Intersection ID: 18166	Main Street: LALEX_LN	Cross Street: E WOODLAWN RD	Location:	SW
ADA ID: 561E76ABED85	Ramp Type: Para	Initial Pass/Fail: Fail	Overall Compliance: No	Severity Score: 13.75

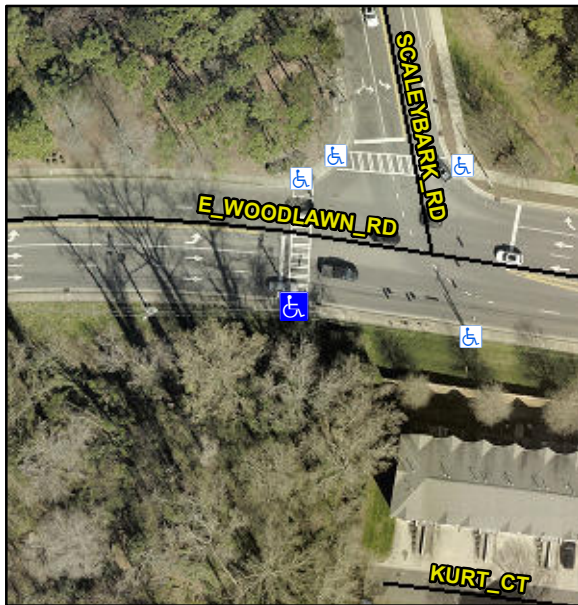
R304.3.2, R304.5.3

Possible Solutions:			Compliance	Description	Data	Compliance	Description	Data
Remove & Replace Entire Ramp.			N/A	Ramp Length LT (in)	73.0	N/A	Ramp Length RT (in)	72.0
			Yes	Ramp Width LT (in)	58.0	Yes	Ramp Width RT (in)	58.0
			No	Ramp Slope LT (%)	8.9	Yes	Ramp Slope RT (%)	5.9
			Yes	Ramp XSlope LT (%)	1.7	No	Ramp XSlope RT (%)	2.3
			N/A	Landing Length (in)	N/A	N/A	DWS Provided?	N/A
			N/A	Landing Width (in)	N/A	N/A	DWS Contrast?	N/A
			N/A	Landing Slope (%)	N/A	N/A	DWS Length (in)	N/A
			N/A	Landing X Slope (%)	N/A	N/A	DWS Full Width?	N/A
			N/A	Landing Curb? (Y/N)	N/A	N/A	DWS Offset (in)	N/A
			N/A	Shared Landing?	N/A			
Surveyor Notes: N/A			N/A	Gutter Ponding?	N/A	N/A	Gutter Slope (%)	N/A
			N/A	Gutter Lip Ht (in)	N/A	N/A	Gutter X Slope (%)	N/A
			N/A	Painted X Walk1?	Yes	N/A	Painted X Walk2?	N/A
				X Walk 1 Direction	To N		X Walk 2 Direction	N/A
			N/A	X Walk 1 Width (in)	110.0	N/A	X Walk 2 Width (in)	N/A

Remove & Replace Entire Ramp.
